Subject: Fire Protection Dedicated Shutdown System  
R. E. Ginna Nuclear Power Plant  
Docket No. 50-244

DEDICATED SHUTDOWN SYSTEM  
CONCEPTUAL DESIGN

R. E. GINNA NUCLEAR POWER PLANT  
Docket No. 50-244

Information Submitted In Response to  
Darrell Eisenhut's letter dated February 20, 1981

R.E. GINNA NUCLEAR STATION  
DEDICATED SHUTDOWN  
480 V POWER DISTRIBUTION  
FIGURE 1

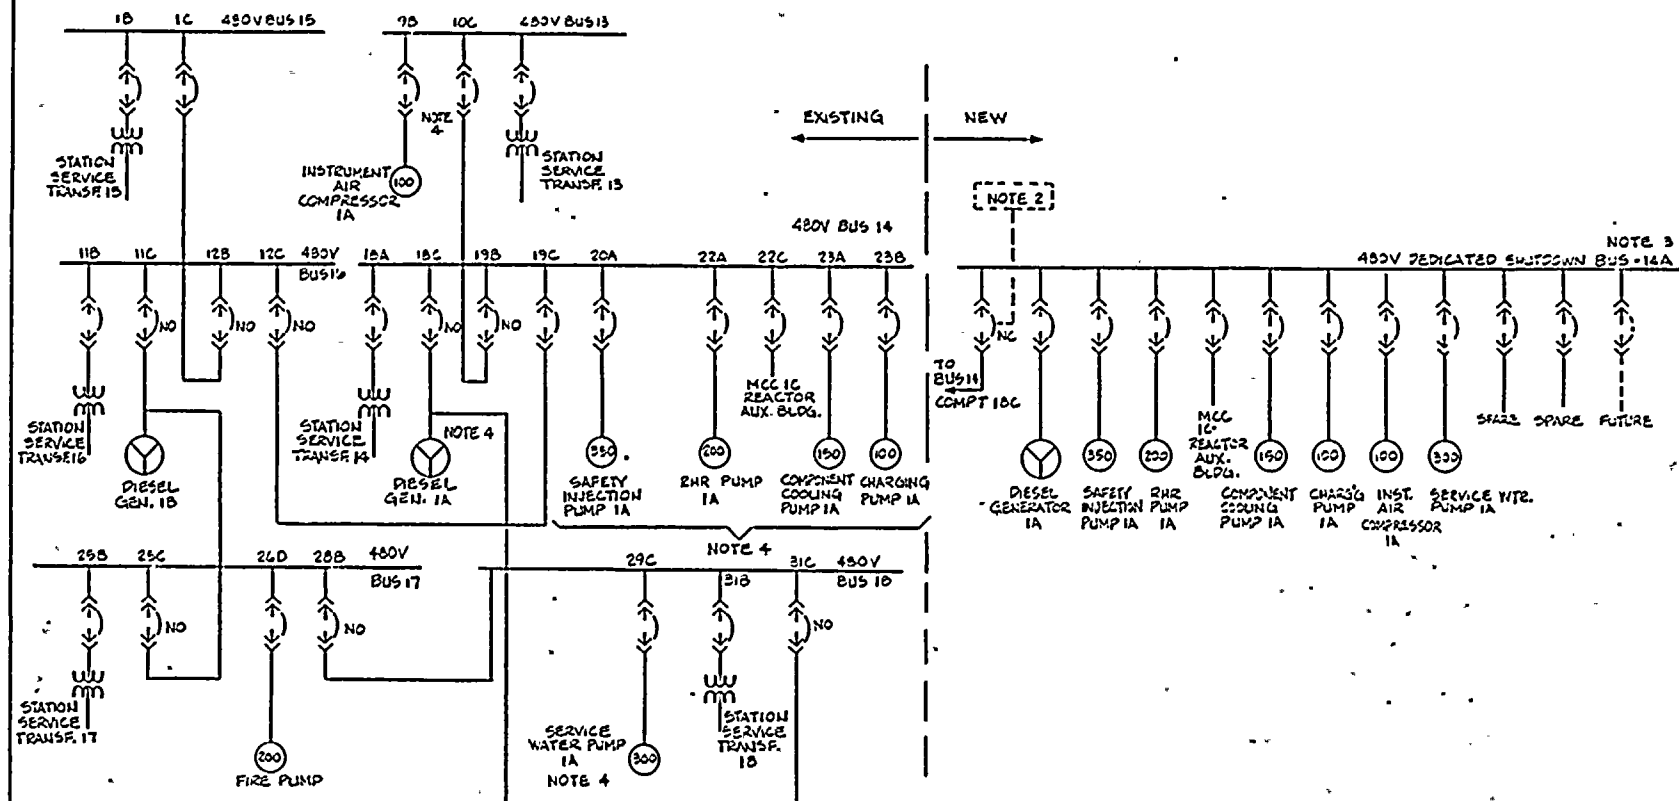
The 480-V safe shutdown loads will be permanently assigned to a 480-V switchgear bus (14A) which can be made separate and independent of the existing switchgear. This configuration is shown on Figure 1. Under normal operating conditions, this bus will be fed from the existing train A switchgear. During and after a fire event, however, this bus will be isolated from the non-shutdown-related switchgear and will be fed directly from the train A diesel generator.
